CROSS-OVER CORRECTION FOR 1968 REVERB & BASS AMPLIFIERS

5-148-1A-2A
3/10 268

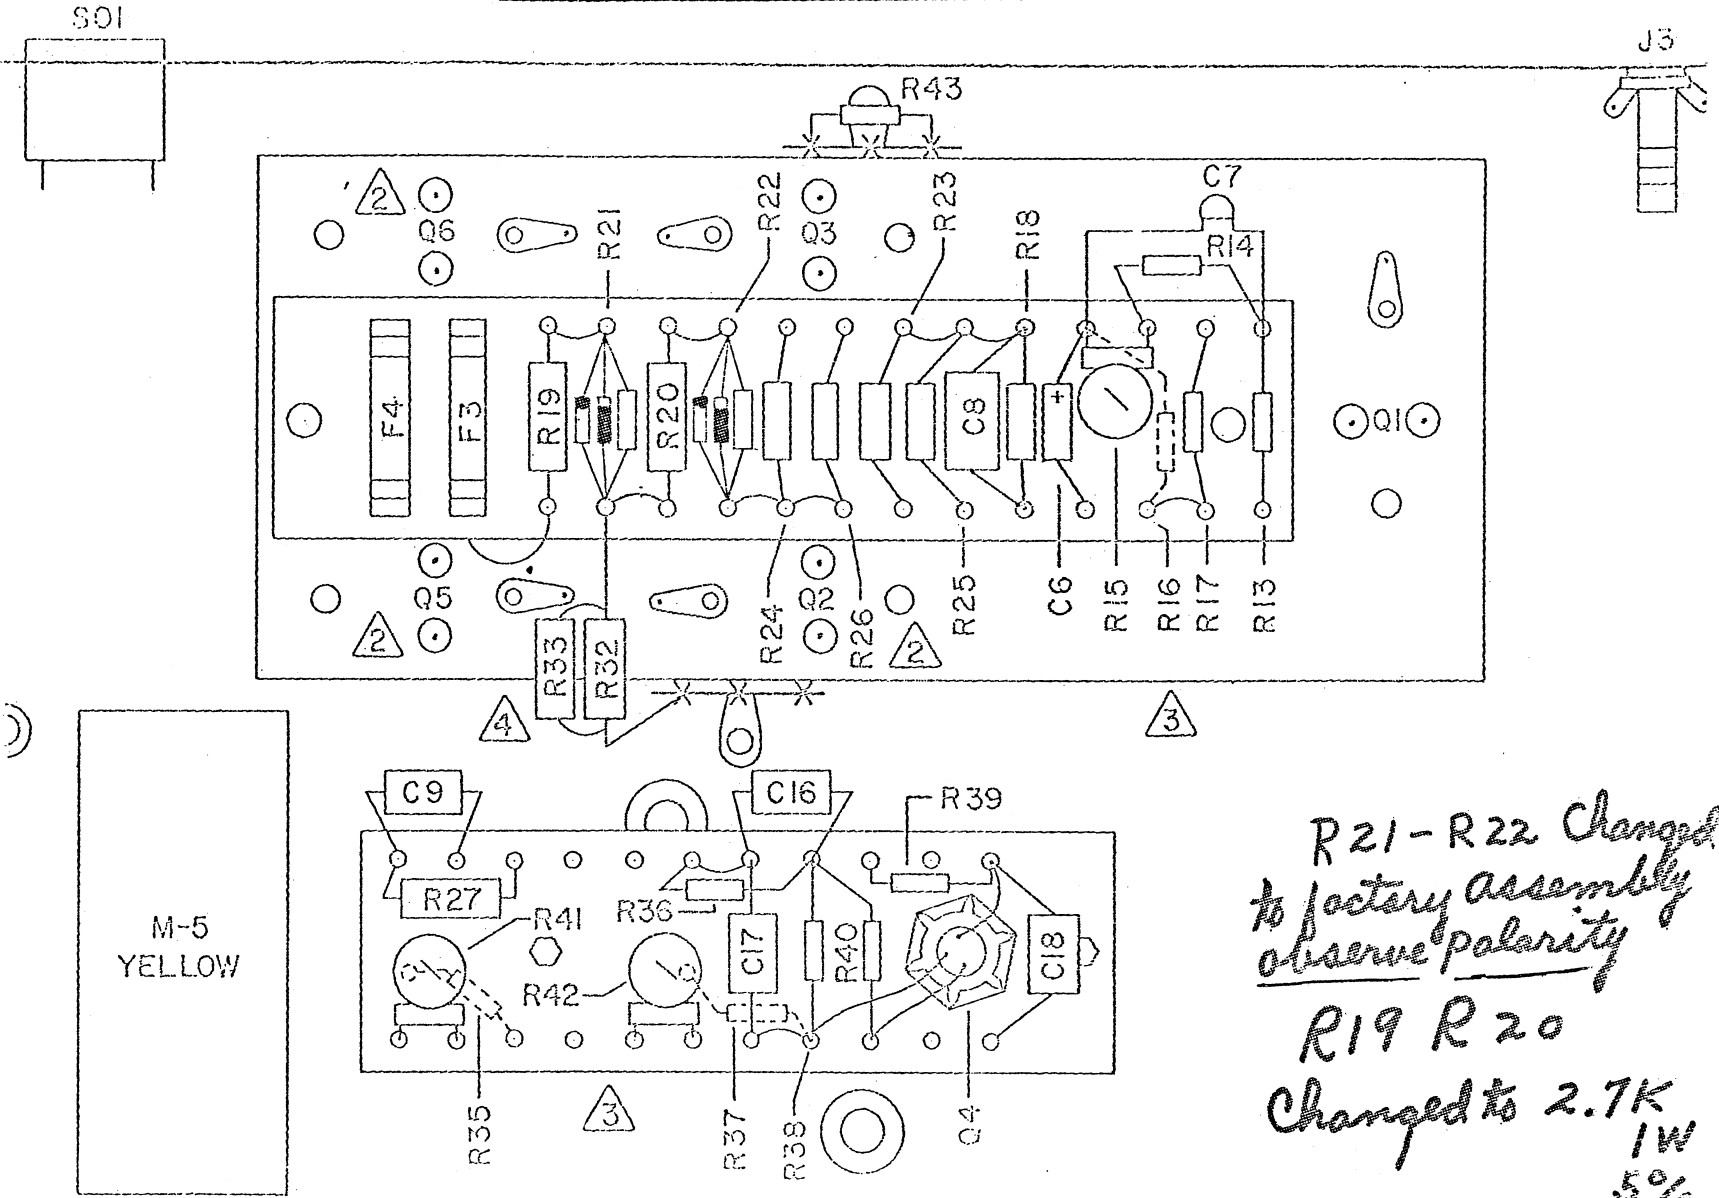
*R21-R22 Changed
to factory assembly
observe polarity*

*R19 R20
Changed to 2.7K
1W
5%*
